Technical product information

Topic	Rattle rear cabin area – Seat belt assembly
Market area	Bentley: worldwide (2WBE)
Brand	Bentley
Transaction No.	2040267/1
Level	EH
Status	Approval
Release date

Rattle from rear of passenger compartment, rear quarter panel area

Figure 1

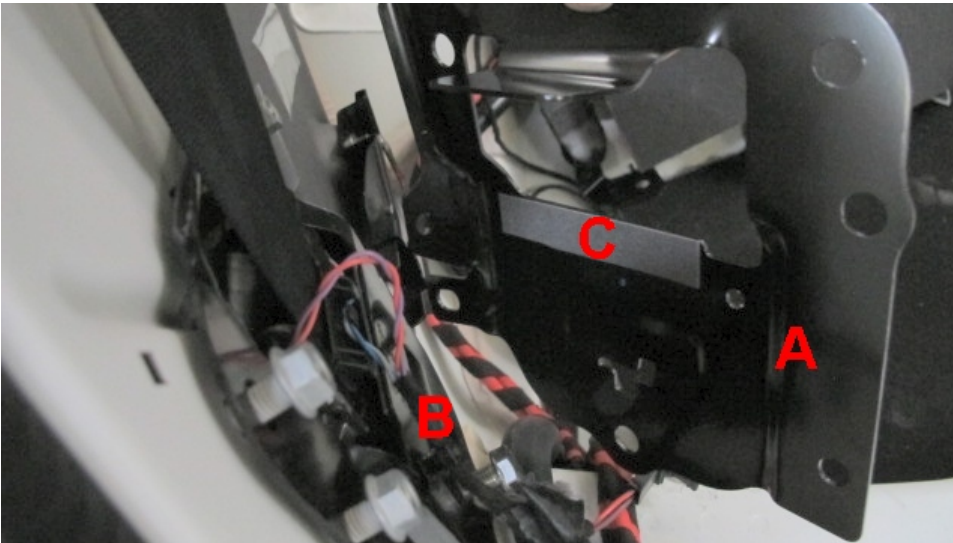
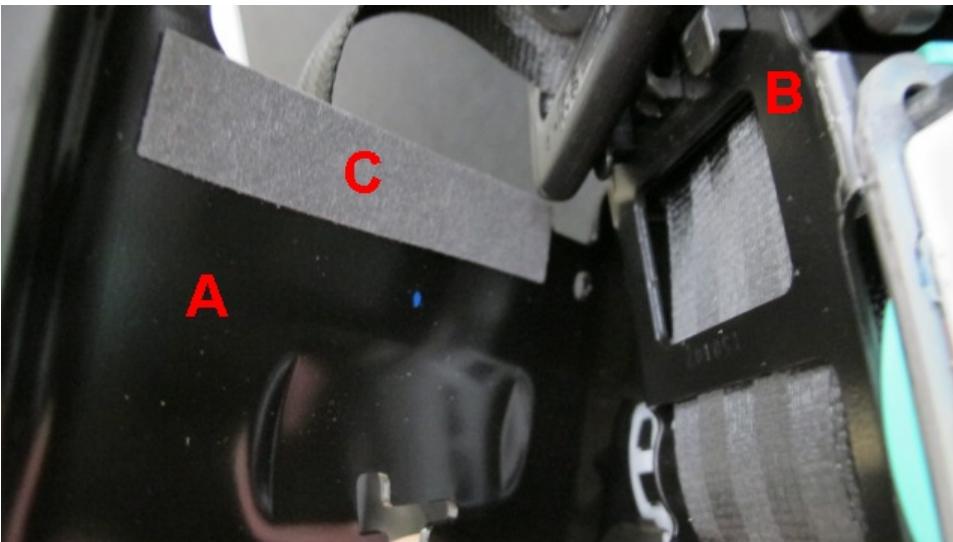
Metal to metal contact between the front seat belt mounting plate and the seat belt reel housing can result in a rattle in the rear quarter panel area

Addition of isolation pad

2. With the seat belt mounting plate (A) separated from the seat belt reel housing (B) apply isolation pad, part number 6N0971799 (C), to the inside face of the seat belt mounting plate (see Figure 1,2 and 3).
